SERVICE No. 1026 BULLETIN

DATE: November 5, 1998 (S/M)

Distribution of Parker Hannifin Airborne Service Letter 48, "Inspection/Replacement of dry air pump flexible couplings".

Service Letter Number: 48

FIGURE 1

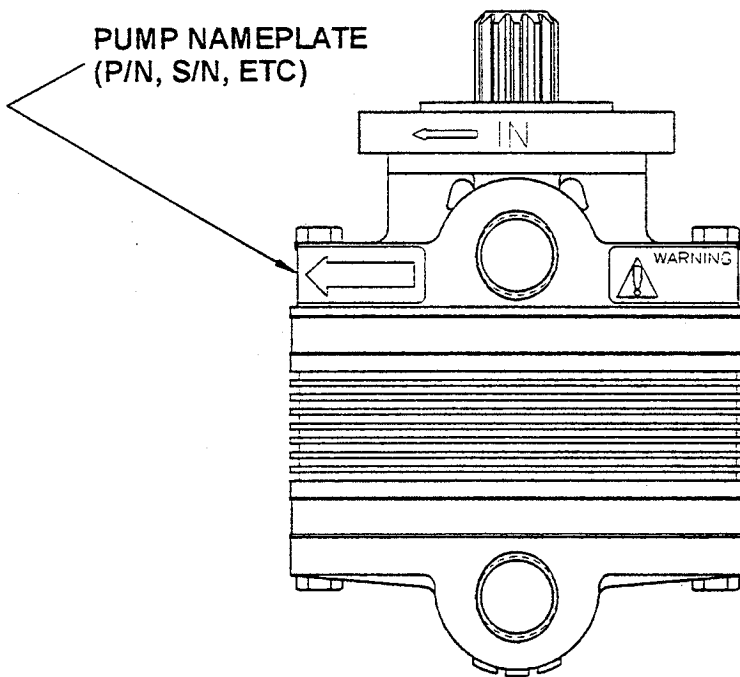
Applicability: Airborne dry air pumps, conversion kits and flexible coupling kits with the following part numbers/serial numbers which have not been inspected per this service letter as identified in step number seven of the procedure listed below. These components were shipped from Airborne between 1/1/98 and 10/13/98. Refer to Figure 1 for location of part number/serial number nameplate.

FIGURE 2

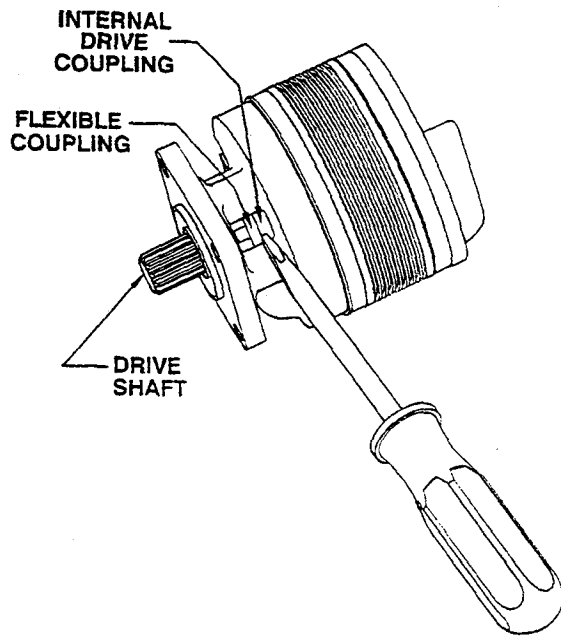
- 1) Remove dry air pump from engine accessory pad per instructions provided by the airframe manufacturer in the appropriate maintenance publication.
- 2) Insert a screwdriver or similar tool between the flexible coupling assembly (2-piece) and the pump's internal drive coupling. Remove the flexible coupling assembly from pump, taking care not to damage any of the eight drive pins. Refer to Figure 2.

- 3) Once the flexible coupling assembly is removed from pump, separate the flexible coupling and drive shaft by inserting a screwdriver or similar tool between the two components. Refer to Figure 3.

- 6) Reinstall the replacement/inspected flexible coupling assembly onto air pump by pushing it over the drive pins of the pump's internal drive coupling as far as it will go. Do not tap coupling assembly with any device as the pump's bearing may be damaged.
